Submission to An Coimisiún Pleanála in Response to Further Information

Proposed Knockshanvo Windfarm

Windfarm Application: ABP-320705-24

29th July 2026

Figure 4: Cumulative 250 m / 500 m comparison

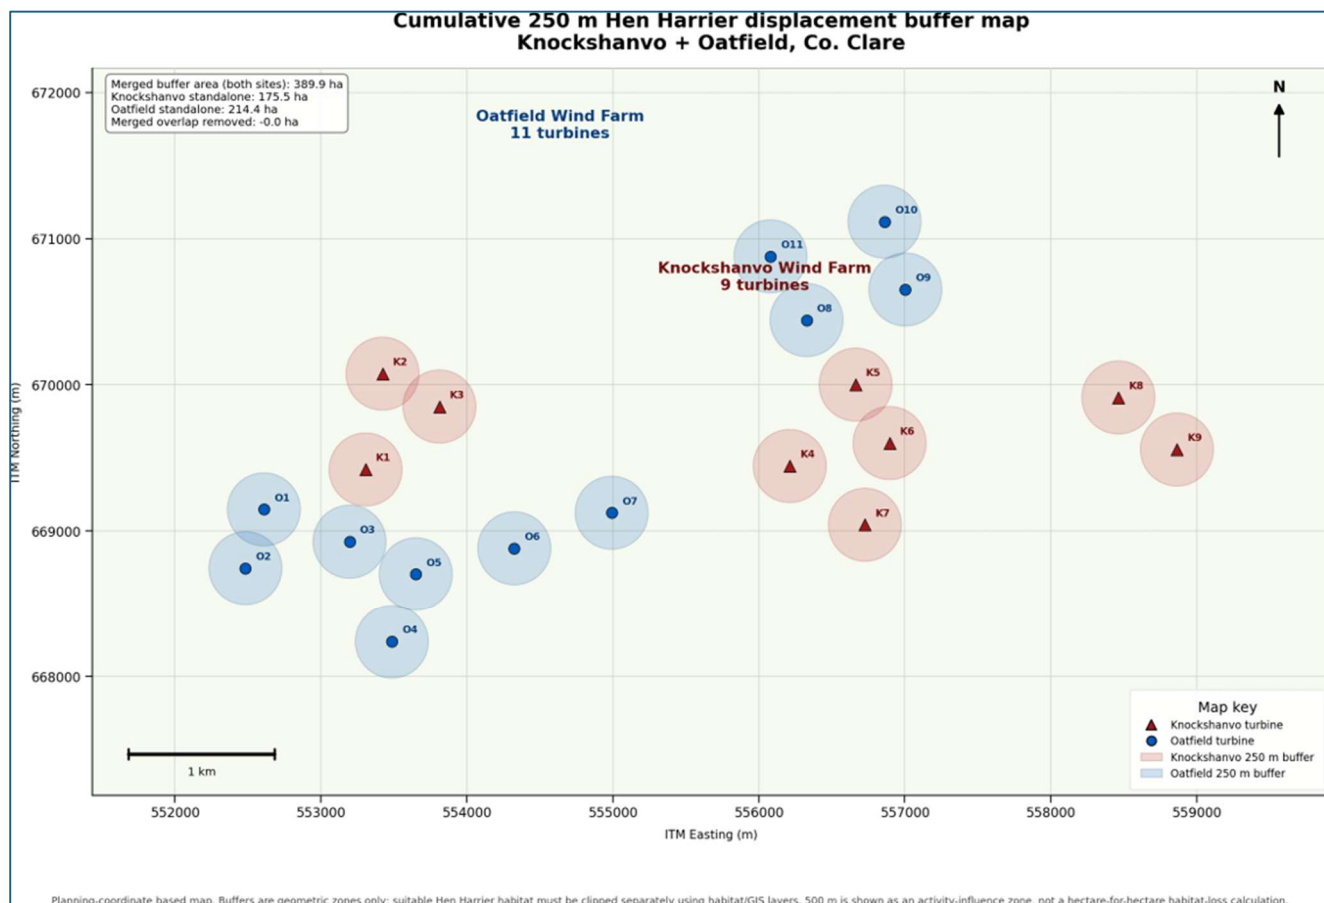
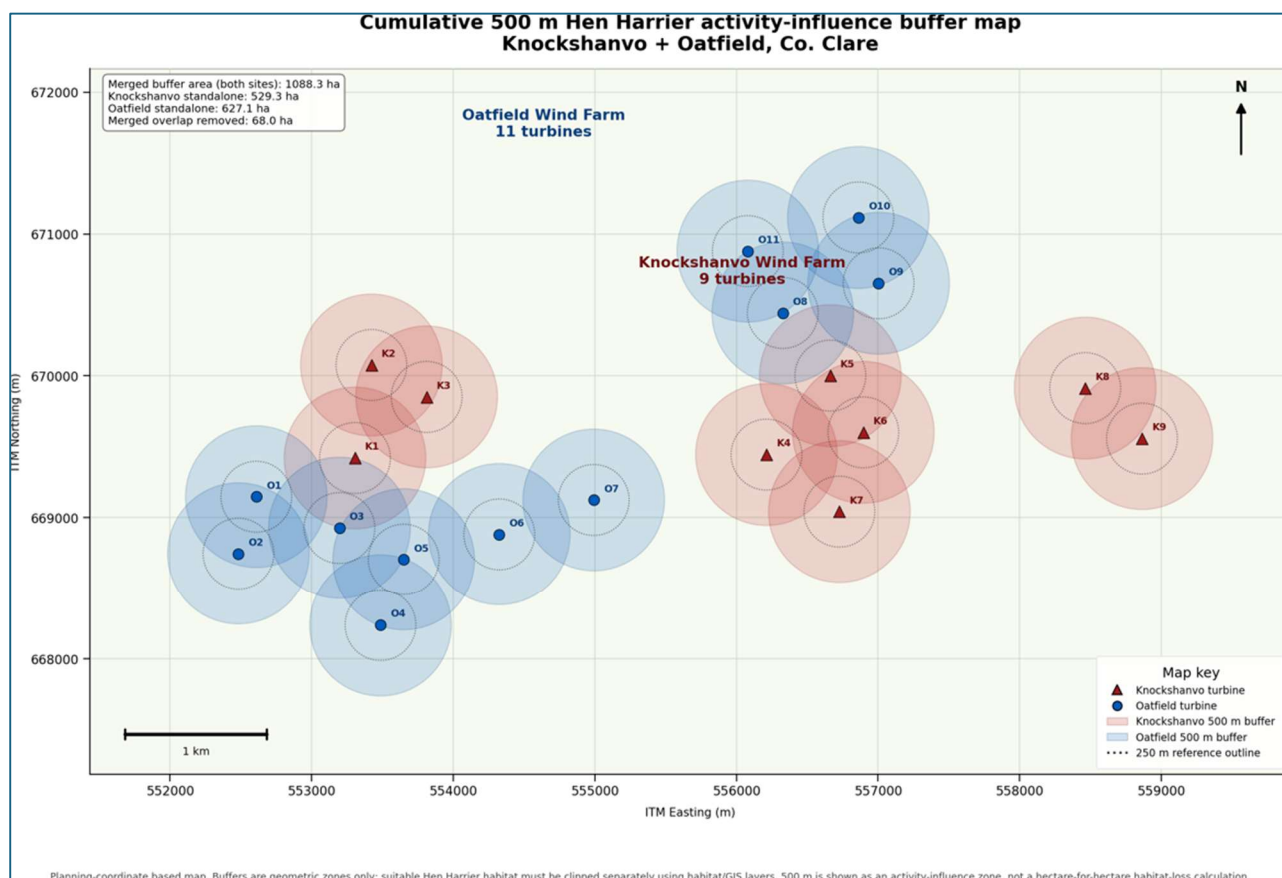
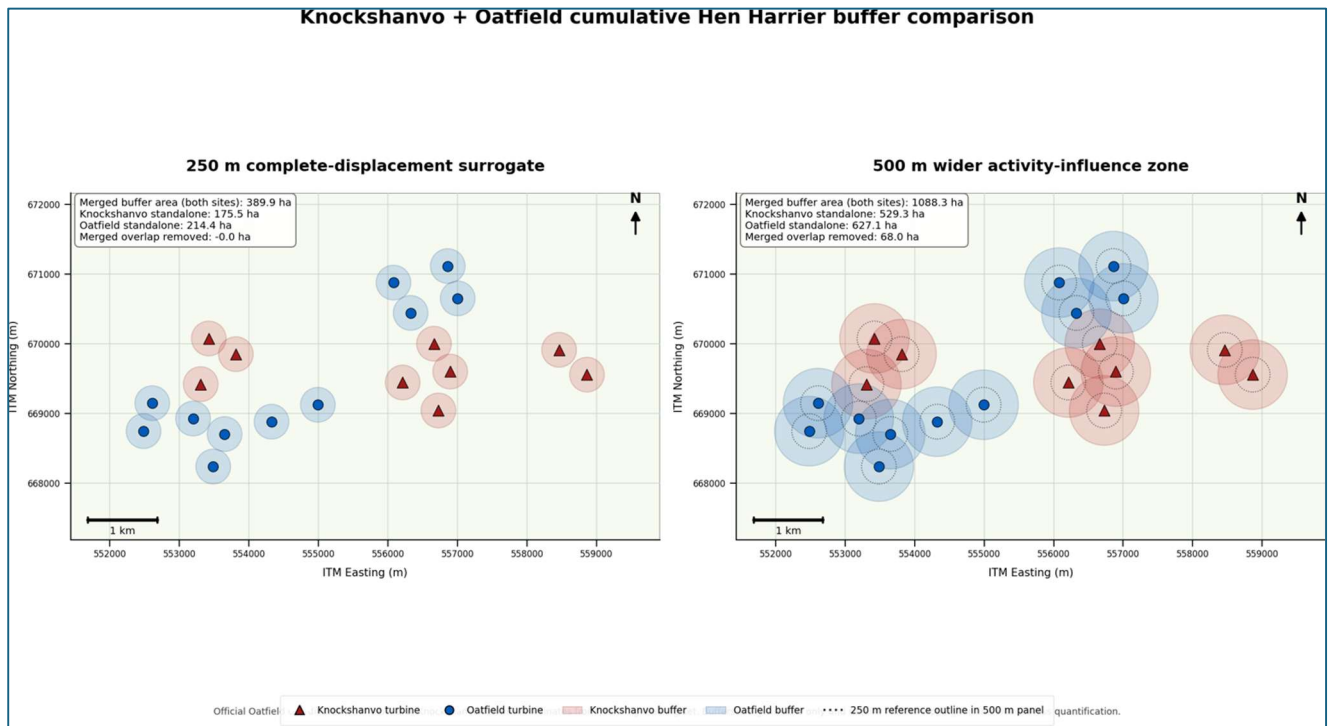
The spatial significance of this issue becomes considerably clearer when Knockshanvo is considered cumulatively with the adjoining Oatfield proposal.

A geometric mapping exercise has been undertaken using the proposed turbine coordinates for both developments. The purpose of this exercise is **not to calculate Hen Harrier habitat loss**, but to illustrate the spatial scale of the cumulative assessment issue.

At the 500 m scale, approximately **68.01 ha of overlap between the Knockshanvo and Oatfield buffers has been removed** in arriving at the combined 1,088.32 ha figure.

These figures are **geometric buffer areas only**. They are not suitable-habitat-clipped and must not be interpreted as Hen Harrier habitat-loss figures. Final quantification would require identification of suitable and potentially suitable habitat within these areas, forestry-cycle modelling, assessment of functional use and appropriate treatment of overlaps.

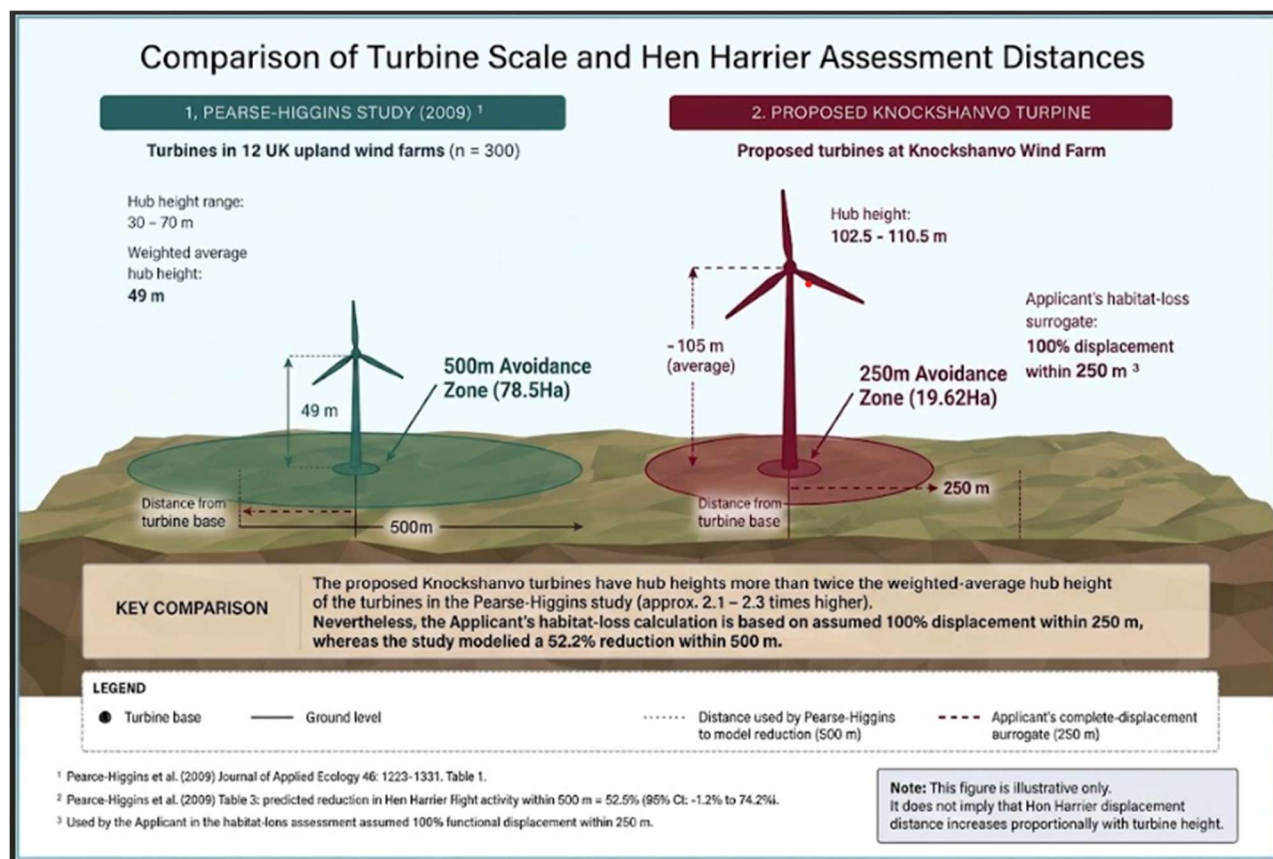
However, the substantial difference in turbine scale raises an important question of **transferability**. The Applicant relies upon an empirical relationship derived from

substantially smaller turbines when determining the spatial extent of Hen Harrier displacement and, ultimately, the quantity of habitat requiring compensation.

The Pearce-Higgins paper does not appear to test turbine hub height as a determinant of Hen Harrier avoidance, nor does it demonstrate that the displacement relationship identified is independent of turbine scale. The study therefore does not, by itself, establish that a displacement surrogate derived from turbines with hub heights of 30–70 m can be applied without adjustment to turbines with hub heights exceeding 100 m.
